REMEDIATION SYSTEM EVALUATION

MCCORMICK AND BAXTER SUPERFUND SITE PORTLAND, OREGON

Report of the Remediation System Evaluation,
Site Visit Conducted at the
McCormick and Baxter Superfund Site
August 23-24, 2001

Final Report Submitted to Region 10
February 8, 2002

FIGURE 1-2. LAYOUT OF THE McCORMICK AND BAXTER PROPERTY INDICATING FORMER FACILITY STRUCTURES, PRIMARY CONTAMINANT SOURCE AREAS, PERTINENT SITE FEATURES, AND APPROXIMATE LOCATION OF THE PROPOSED VERTICAL BARRIER WALL.

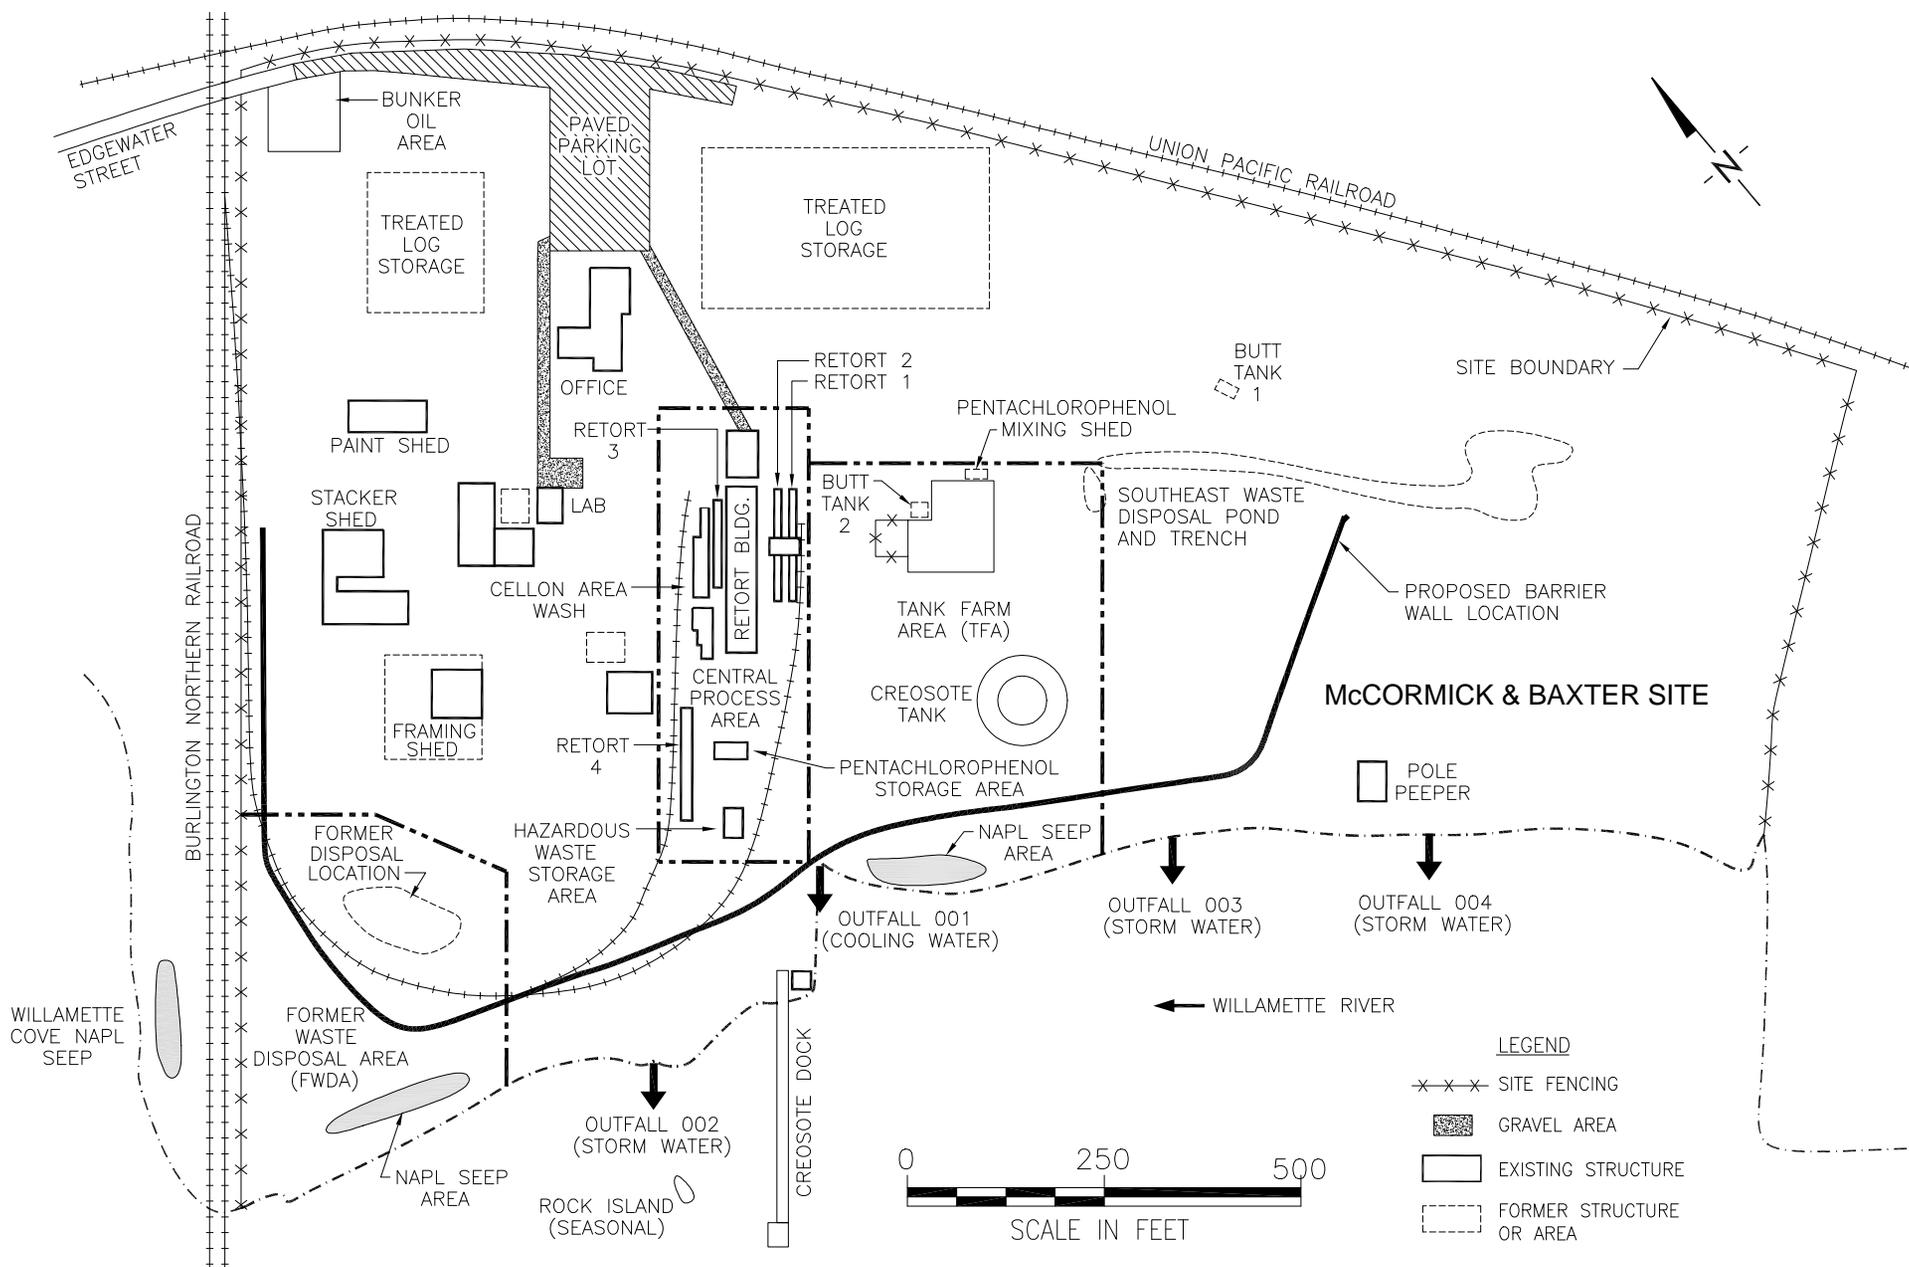
According to the site managers, a barrier wall will be installed and will likely have a configuration similar to that shown in Figure 1-2. It will be keyed into the low permeability layer in most areas where one exists but will be “hanging” in areas like the FWDA where the low permeability layer does not exist. The site managers expect the wall to contain the unquantified amount of NAPL remaining onsite. Efforts, however, may be required to prevent migration of NAPL through the “hanging” portions of the wall. Due to the lower installation costs, site managers will likely have the wall constructed of a bentonite slurry rather than sheet piling.

Because the planned barrier wall will be approximately 50 feet from the from the edge of the river and 500 feet from the outer limit of the NAPL contaminated sediments, a significant amount of mobile NAPL may exist beyond the influence of the wall and may continue to impact the river through seeps. To contain some of this NAPL, interceptor trenches may be installed along the beach in both the Willamette
